Sent:15/12/2022 10:07:20 AMSubject:27 Waine Street DA2022/1985Attachments:Photos Unit 4 25 Waine Street.pdf; Edwina Annand DA submission.pdf;

Planning Officers Northern Beaches Council c/o Maxwell Duncan

Current Outlook – Sitting Room Windows 13/12/22

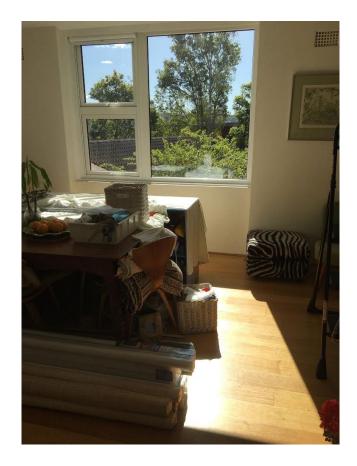
Future Outlook – If DA is approved

The project will overshadow a number of its neighbours at 25 Waine Street, causing a highly substantial loss of light and privacy to all 6 units facing west.

Each unit on the plan has windows that face directly into ours breaching our rights to privacy and security from onlookers and the protection of our views.
